**CITY OF BOULDER**  
**PLANNING BOARD AGENDA ITEM**  
**MEETING DATE: Aug. 18, 2016**

**AGENDA TITLE:** CONCEPT PLAN & REVIEW - Redevelopment of the existing seven-acre apartment site located at 1550 Eisenhower Drive with a new three-story apartment complex Eastpointe Apartment Homes, consisting of 236 proposed units in five buildings with below grade parking and on-site recreational amenities under case review no. LUR2016-00043.

**SUMMARY:** CONCEPT PLAN & REVIEW – Proposal for five new three-story apartment buildings, a fitness building and associated site amenities with below grade parking. A total of 236 apartment units are proposed where 140 units exist today.

Figure 9: Urban Design Suggestions to Applicant regarding Concept Plan

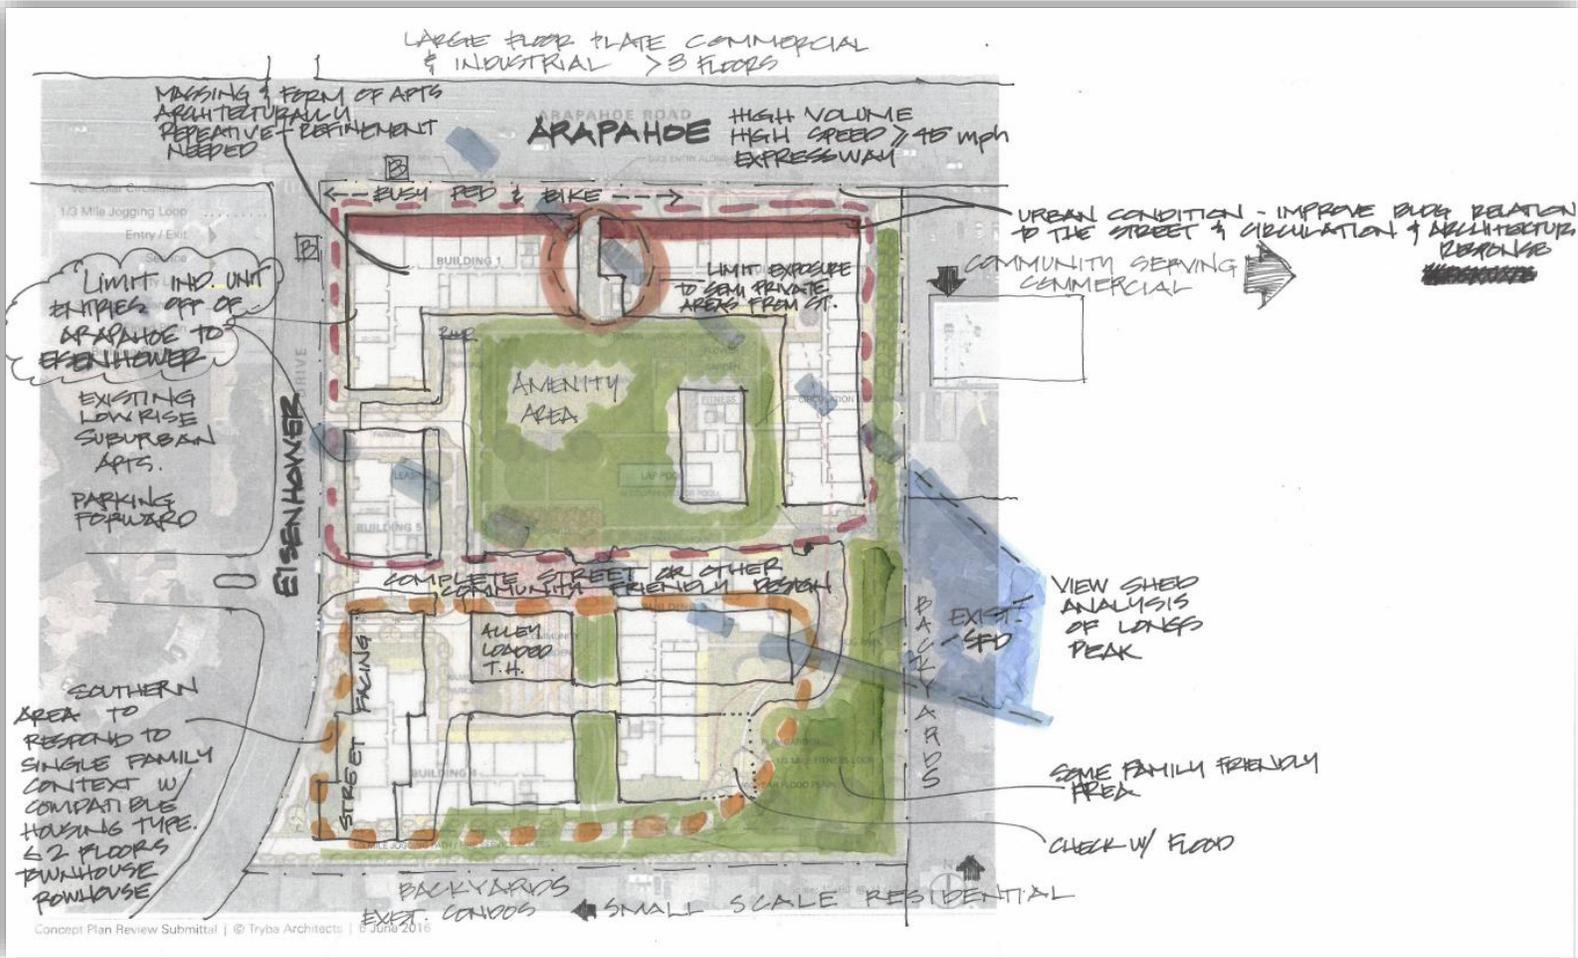
Recognizing the high density land use and zoning on the site and the typology of Arapahoe Avenue, the northern portion of the site can accommodate bigger buildings and a greater degree of intensity however, the proposed site plan should consider the existing surrounding residential uses that are smaller in scale and stature, particularly the single family detached homes to the south. The Site Plan should consider the following to better address the context and surroundings, and as shown in the graphic on the following page in **Figure 9**:

- Break up the superblock by creating a distinct transition to a less massive building type and units on the south side of the site, with the transition being a complete street as shown in **Figure 9**.
- Improve the building’s relationship to the street, and circulation and architectural response as the buildings could create more of an urban edge to the broad right-of-way of Arapahoe Avenue, rather than be setback by approximately 50 feet as shown on the Concept Plan, with private yard space along Arapahoe Avenue.
- Limit individual unit entries off of Arapahoe Avenue, given the high volume arterial, and instead provide for overall building entries off Arapahoe and individual unit entries off of Eisenhower.

- The massing and form of the apartments over five buildings is architecturally repetitive. It is understood that the architectural style, as proposed and shown in precedent images (Figure 10) do provide interest, having uniform buildings across the site as shown is discouraged.

**Figure 11: Exterior Material Proposal**

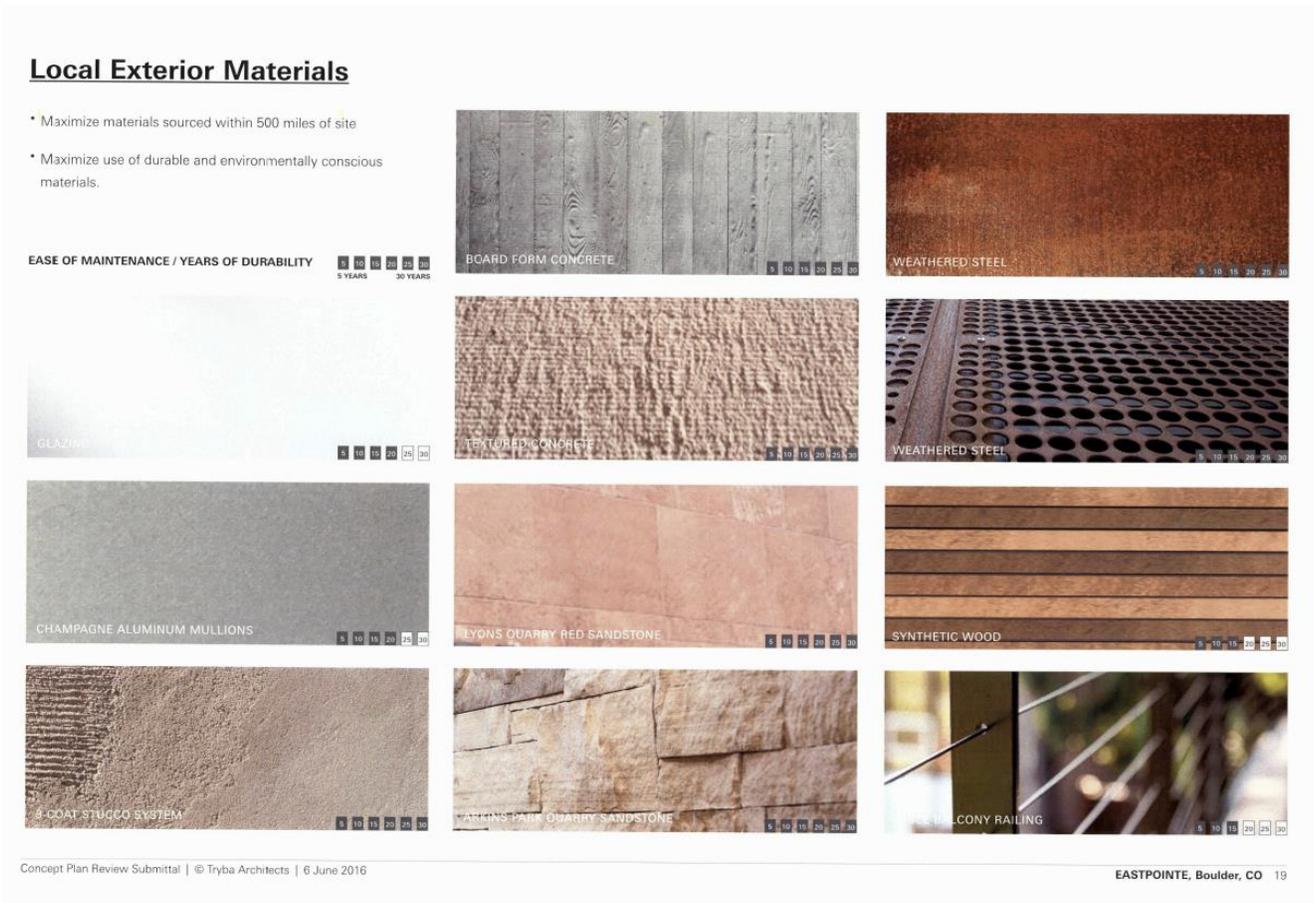
- As discussed with the applicant in a review of the comments, staff and the applicant concurred that some edges or portions of buildings should be converted to two-story massing. Similarly, while the early proposal for exterior materials (shown in **Figure 11**) does appear to be durable and of high-quality, staff recommends reconfiguring the finish materials distinctly on different buildings, such that the buildings don't appear as a duplications of one another.
- The building typology on the south end of the site should consider more of a townhome configuration to transition to the adjacent single family residential and smaller apartment buildings.
- Setback units from southeast property line and perform a viewshed analysis from adjacent neighborhood to preserve view corridors to the northwest.

# Proposed Site Plan

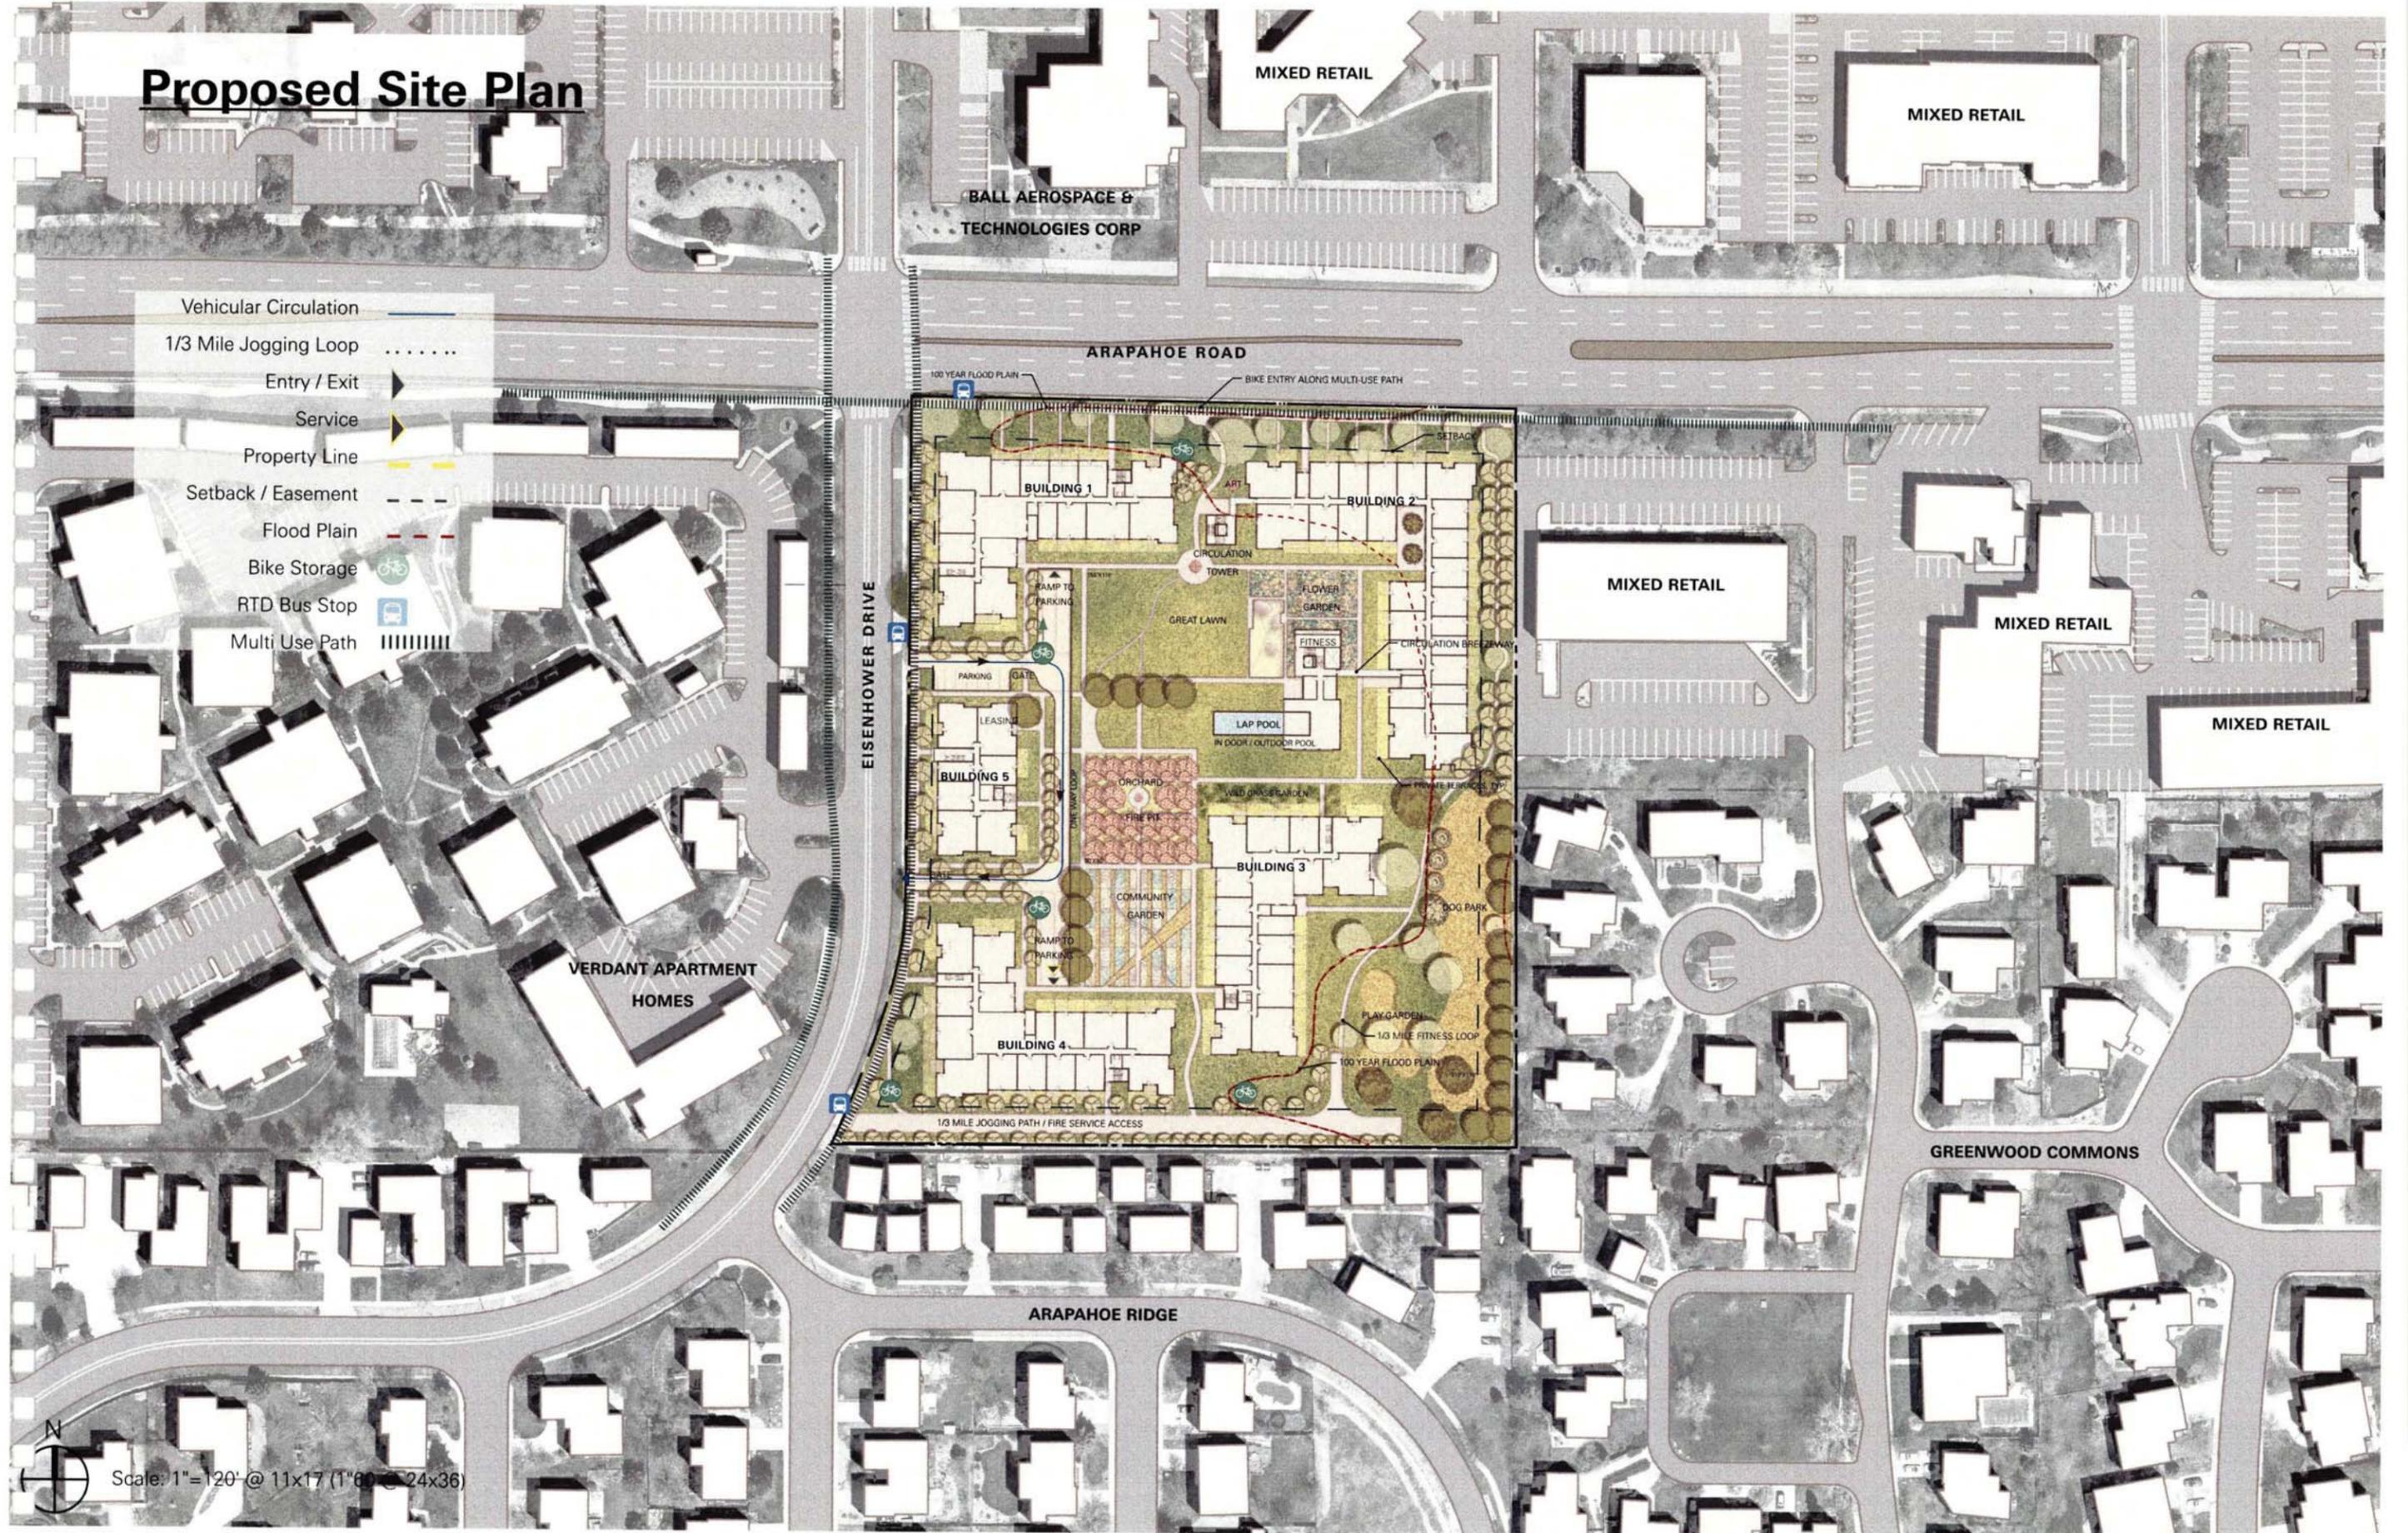
This site is impacted by the 100-year floodplain of South Boulder Creek and the Proposed Site Plan shows the northeastern corner of Building 1 and all of Building 2 to be located within the floodplain. A floodplain development permit will be required for all development within the 100-year floodplain. The floodplain development permit shall contain certified drawings demonstrating:

The East-West Site Section on page 17 of the Concept Plan package, the Proposed Site Plan seem to indicate a proposed connection between Building 2 and the circulation tower. Building 2 must be completely disconnected from all other structures on the site. A connection to a structure that is located within the floodplain will cause the entire structure to be considered within the floodplain, requiring elevation of all levels, including the below grade parking structure to a minimum of two feet above the base flood elevation.

BUILDING 2 HAS BEEN DESIGNED WITH THE FIRST FLOOR 24 INCHES ABOVE THE HIGH WATER MARK OF A 100-YEAR FLOOD EVENT

# Diagram #1a - Site Plan Development

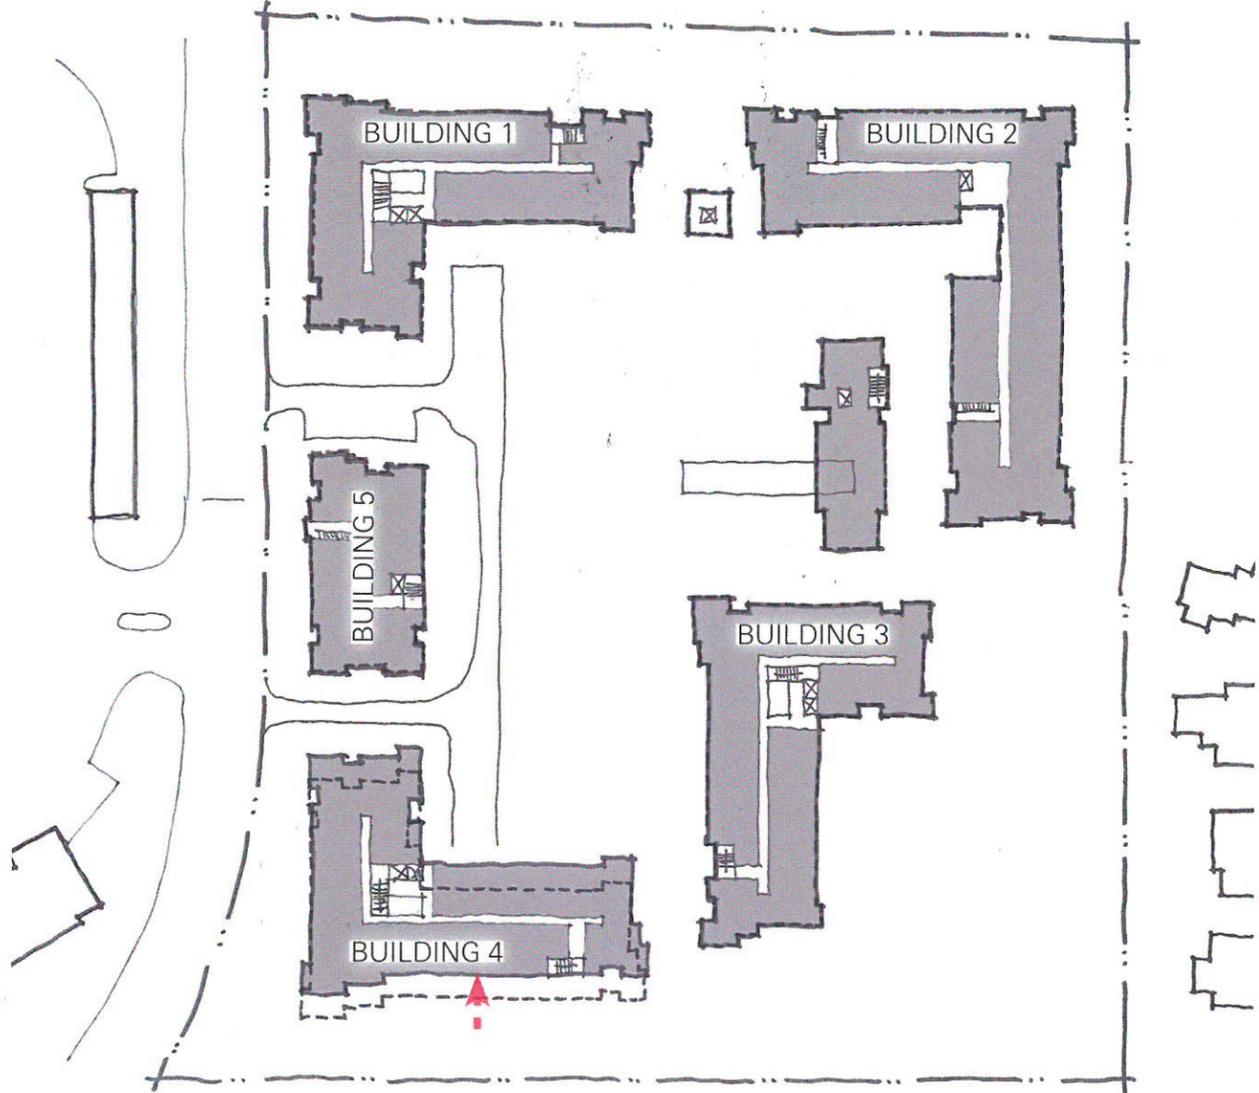
MOVE BUILDING 4 NORTH 12 FEET  
• TO MAINTAIN VIEWS FOR NEIGHBORS
